Interactive comment on “Modeling the Glacial Lake Outburst Flood Process Chain in the Nepal Himalaya: Reassessing Imja Tsho’s Hazard” by Jonathan M. Lala et al.

Jonathan M. Lala et al.

Received and published: 25 May 2018

Fig. 1. WorldView-2 (0.5 m; DigitalGlobe, Inc.) imagery of the lake before (14 May 2016) and after (29 October 2016) the lake lowering project

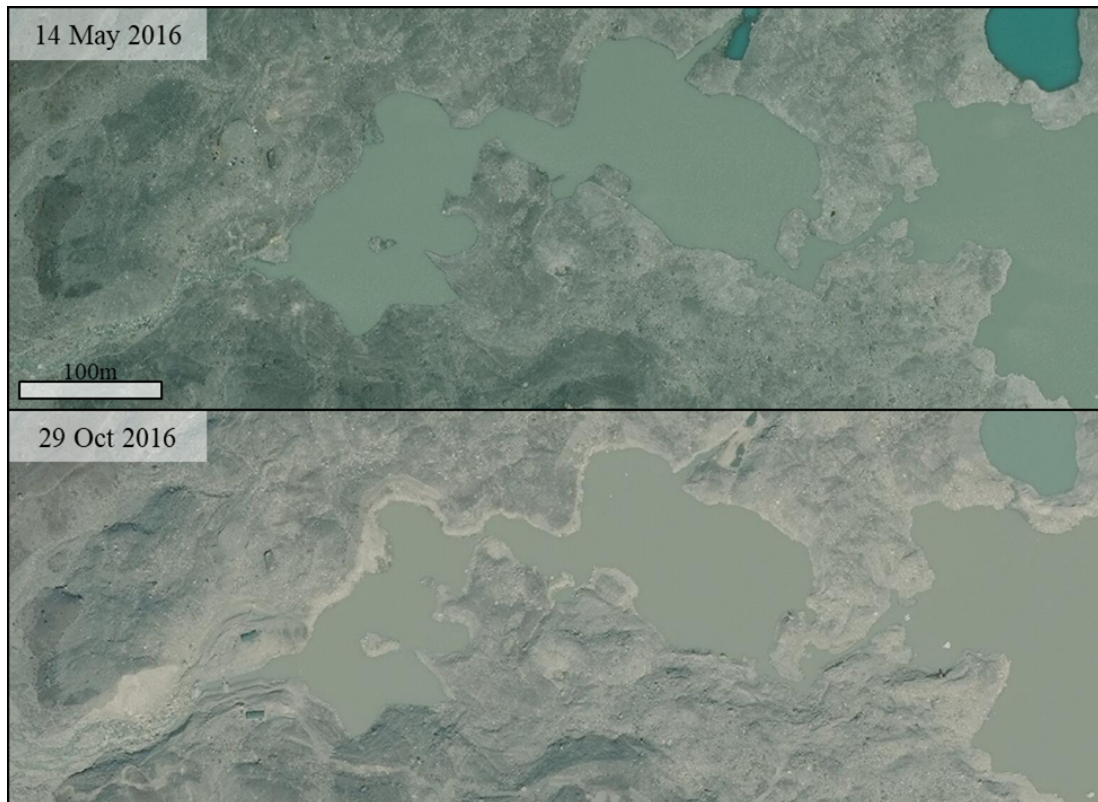
First, the authors have made a good case here for undertaking this study, and have outlined clearly how their modelling approach compares with previous efforts. This indicates novelty in their work. However, Imja Tsho made headlines in October 2016 when the Nepalese Army were deployed to undertake some engineering work to lower the lake, and thereby reduce GLOF hazard. Whilst the authors allude to this recent change briefly in the Introduction (P2 L23), it seems that this change (reported by the BBC to be a lowering of 3m) has not been considered in this study. For example, the bathymetric survey undertaken by the authors was completed in June 2016, several months before the lake lowering. Ultimately, my question here is: to what extent does the manual lake lowering affect the relevance of your results? For example, maybe the lake lowering by the army is insignificant in the grand scheme of things because the glacier will continue to recede (as you say in section 2.2), and occupy new overdeepenings, etc. But I think there should be more mention and consideration of this recent change in the size/volume of the lake.

The reviewer rightly points out that the lake lowering project is only mentioned briefly, and it is true that a significant lowering of the lake level would affect the results. Imagery from before and after the lake lowering (Figure 1 in this response, Figure 3 in revised manuscript) shows a clear ring of discoloration and decrease in area at the outlet ponds, but not in the main part of the lake, indicating that the latter may not have been lowered to the same extent. The authors decided to remain conservative in

the hazard assessment by assuming that the lake was not lowered. A paragraph has been added to section 2.2 and reads as follows: “Although the lake was subjected to a lowering project in the summer of 2016 that reportedly lowered the lake by 3 m (BBC World Service, 2016), this lowering was not accounted for in the GLOF process chain modeling as it is unclear how much the main lake was lowered based on repeat satellite imagery (Figure 3). Specifically, WorldView-2 (0.5 m; DigitalGlobe, Inc.) images of the lake’s outlet complex before and after the lowering project show a clear ring of discoloration and decrease in area around the outlet ponds, but the lack of discoloration near the shore of the main lake suggests that the main lake may not have been lowered to the same extent. Hence, the GLOF process chain was modelled conservatively by not accounting for any lake lowering.”
